11 BOOLA PLACE, CROMER NSW

BCA 2022 COMPLIANCE REPORT FOR CONSENT AUTHORITY SUBMISSION

DATE: 25 AUGUST 2023
REPORT NO: 2936 – REV B FINAL
PREPARED FOR: THE BOOLA PLACE TRUST
PREPARED BY: AM | J² BCA CONSULTING

Figure A – Access to the principal entrance of the building

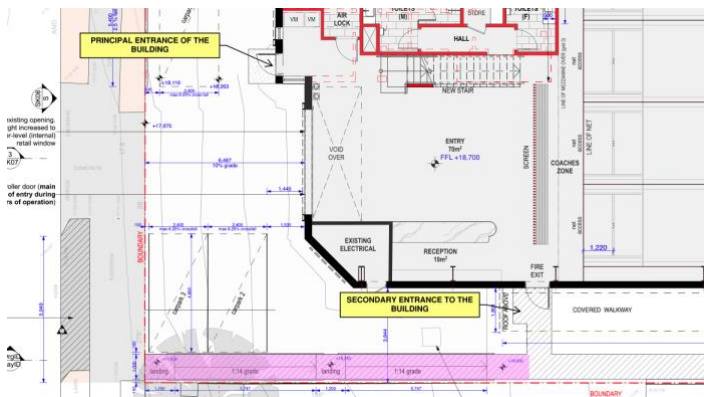
2.	D4D3 <i>D3.2</i>	Access to buildings Access is required from the main points of a pedestrian entry at the allotment boundary and from any required accessible carparking spaces on the allotment. It is proposed to provide access to the secondary entrance from Boola Place in lieu of the primary entrance to the building, considered the entrance located adjacent Carpark 1 at the front of the site. The proposed arrangement proposes a 1:14 ramp accessing the building from the street provided with landings located top and bottom of the ramp and an intermediate landing. Whilst access to the secondary entrance is not considered the primary entrance of the building the accessway generally complies with AS1428.1-2009. The proposed arrangement is shown below:	It is proposed to address this item via an Access Performance Solution to consider access to be provided to the secondary entrance in lieu of the main entrance from Boola Place.

Figure B - Handrail construction

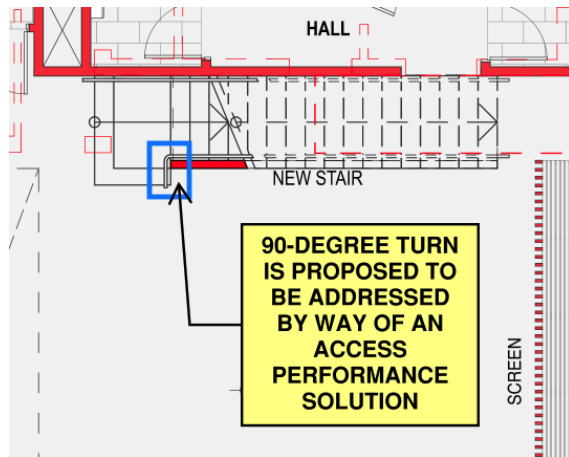
It is also proposed to address then 90-degree turn of the handrail located at the base of the stair by way of an Access Performance Solution. This area is shown below:

Figure C - Upper level access requirements

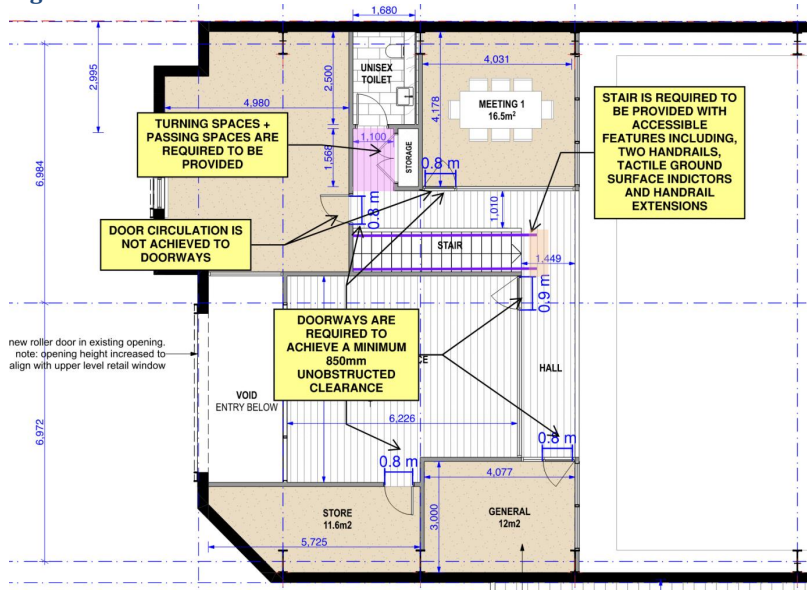
NO.	DTS CLAUSE	DESCRIPTION OF NON-COMPLIANCE	RECOMMENDATION
3.	D4D4 D3.3	<p>Parts of buildings to be accessible</p> <p>As the upper level of the building is a Class 5 and 6 portion of the building, and the storey is less than 200m² a passenger lift is not required to be provided to the upper level. However, the upper level is required to be accessible for ambulatory requirements. This requires the following:</p> <ul style="list-style-type: none"> The stair is required to be provided with accessible features, including tactile ground surface indicators, two handrails, handrail extensions. All doorways are required to achieve door circulation (Clause 13.3 of AS1428.1-2009). Doors are required to achieve a minimum 850mm unobstructed clearance. Turning/passing spaces are required within the corridor. 	<p>It is proposed to address these deviations by way of an Access Performance Solution to comply with the Performance Provisions of the BCA.</p>

Figure 3 – Access to the principal entrance of the building

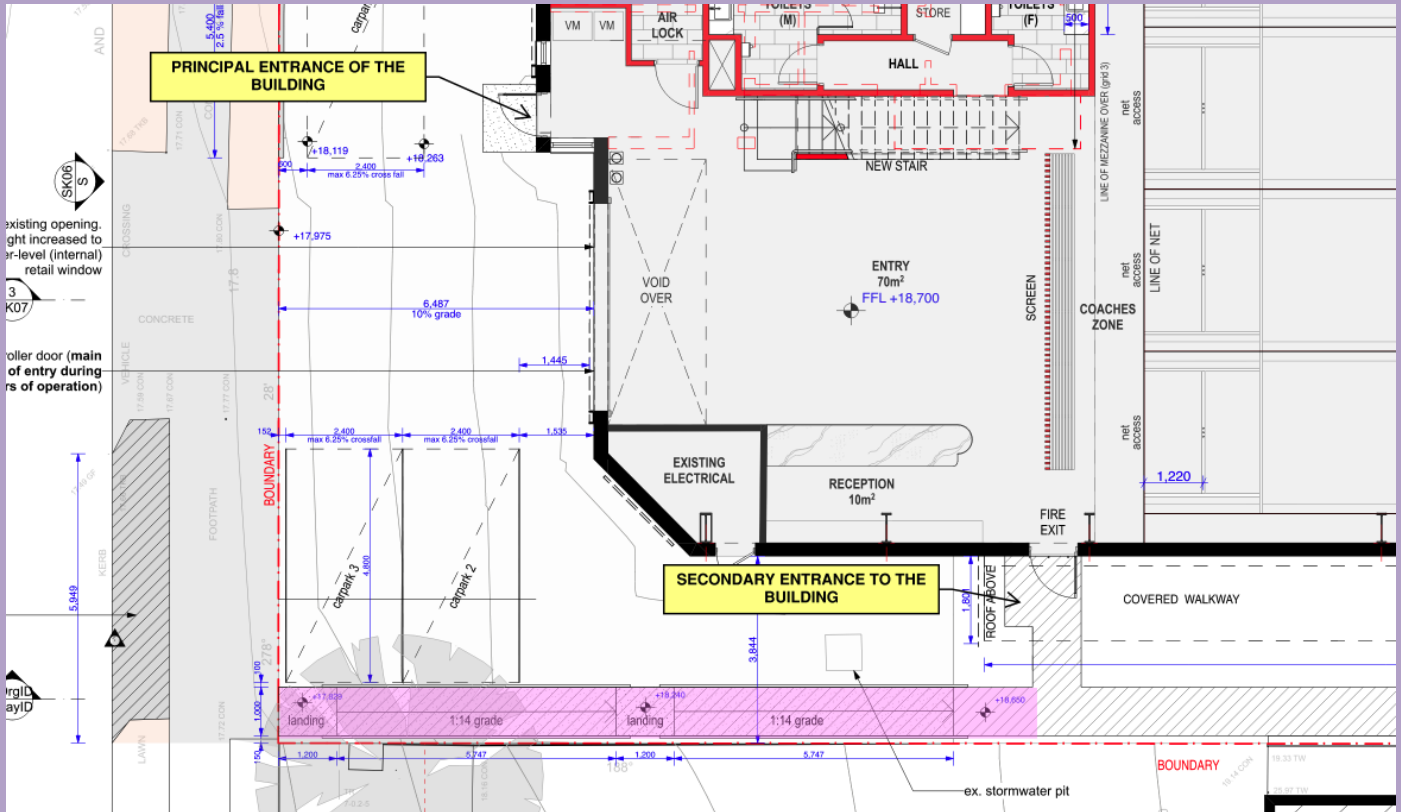
D4D1 <i>D3.0</i>	Deemed-to-Satisfy Provisions	✓	✓	Noted.
D4D2 <i>D3.1</i>	General building access requirements	✓	Compliance advice	Buildings are required to be accessible unless otherwise exempt by BCA Clause D4D5. Class 5, 6 and 9b buildings are required to be accessible to and within all areas normally used by the occupants.
D4D3 <i>D3.2</i>	Access to buildings	✓	X	Access is required to the following areas: From the main points of a pedestrian entry at the allotment boundary and from any required accessible carparking spaces on the allotment. It is proposed to provide access to the secondary entrance from Boola Place in lieu of the primary entrance to the building, considered the entrance located adjacent Carpark 1 at the front of the site. The proposed arrangement proposes a 1:14 ramp accessing the building from the street provided with landings located top and bottom of the ramp and an intermediate landing. Whilst access to the secondary entrance is not considered the primary entrance of the building the accessway generally complies with AS1428.1-2009. The proposed arrangement is shown below: It is proposed to address this item via an Access Performance Solution to consider access to be provided

to the secondary entrance in lieu of the main entrance from Boola Place.

Figure 4 - Handrail construction

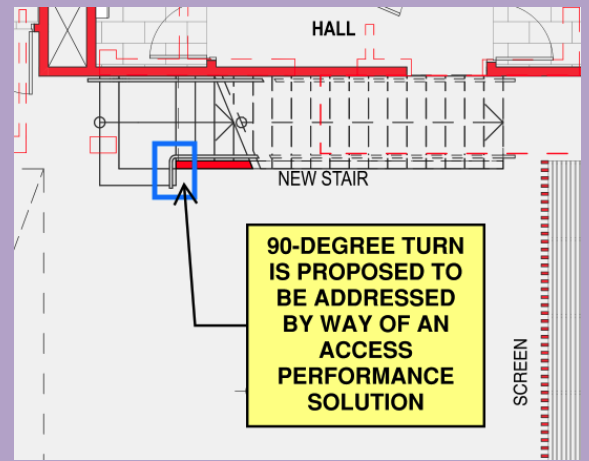
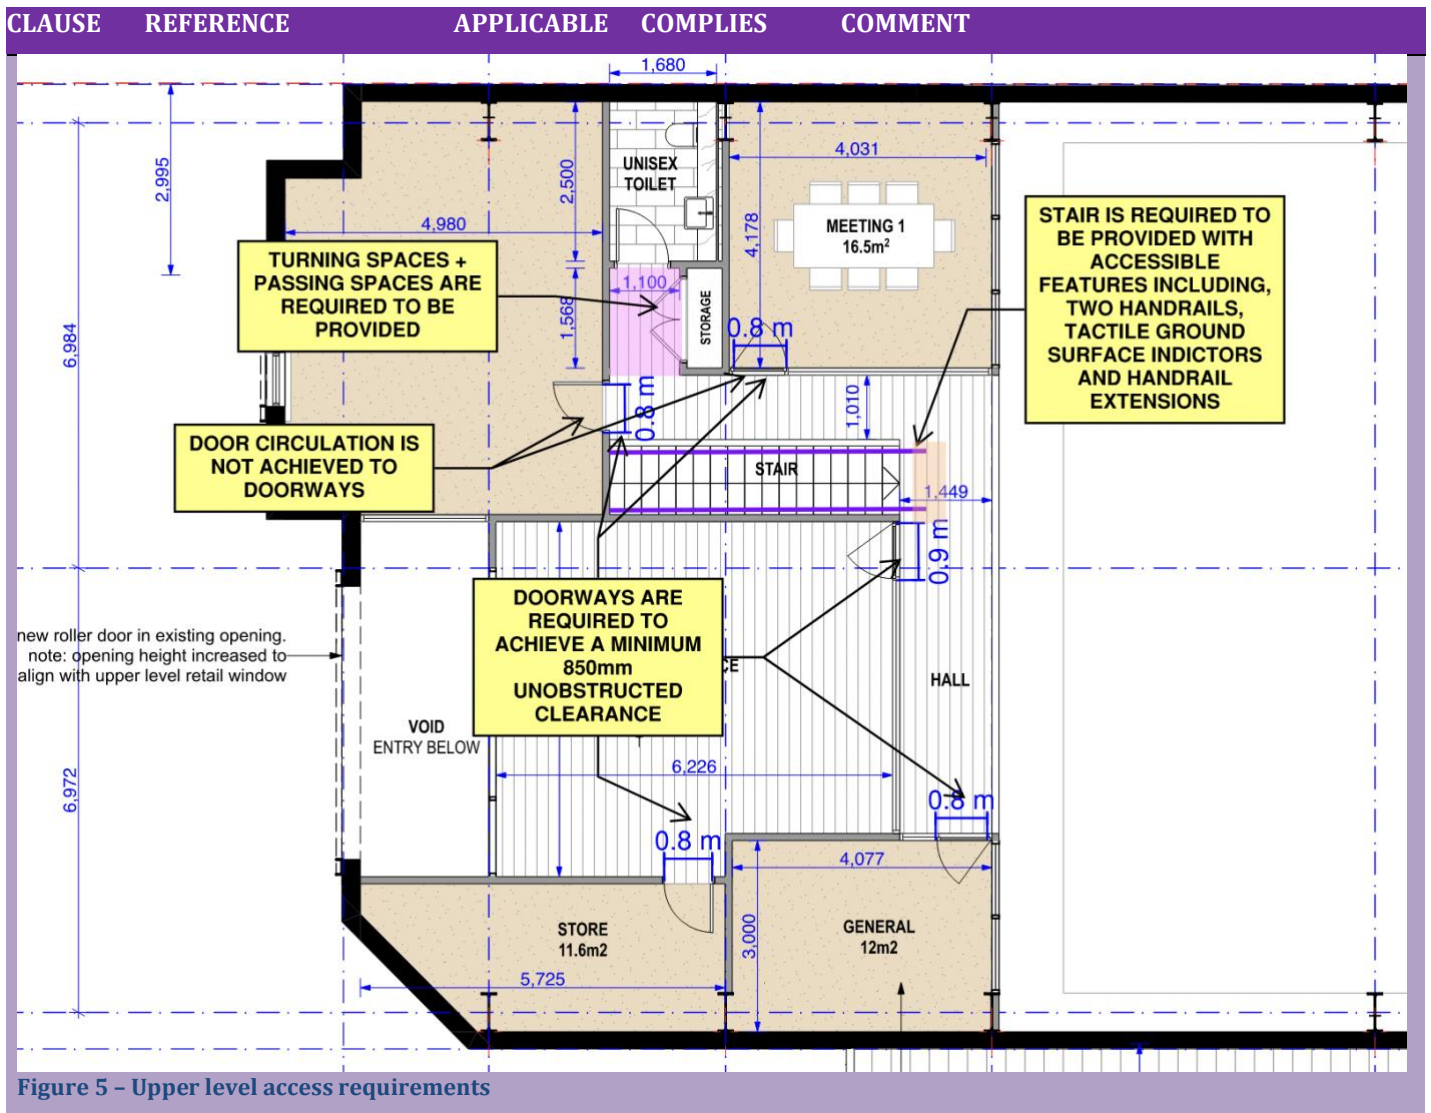
As the upper level of the building is a Class 5 and 6 portion of the building, and the storey is less than 200m² a passenger lift is not required to be provided to the upper level. However, the upper level is required to be accessible for ambulatory requirements. This requires the following:

- The stair is required to be provided with accessible features, including tactile ground surface indicators, two handrails, handrail extensions.
- All doorways are required to achieve door circulation (Clause 13.3 of AS1428.1-2009).
- Doors are required to achieve a minimum 850mm unobstructed clearance.
- Turning/passing spaces are required within the corridor.

It is also proposed to address then 90-degree turn of the handrail located at the base of the stair by way of an Access Performance Solution. This area is shown below:

It is proposed to address these deviations by way of an Access Performance Solution to comply with the Performance Provisions of the BCA.
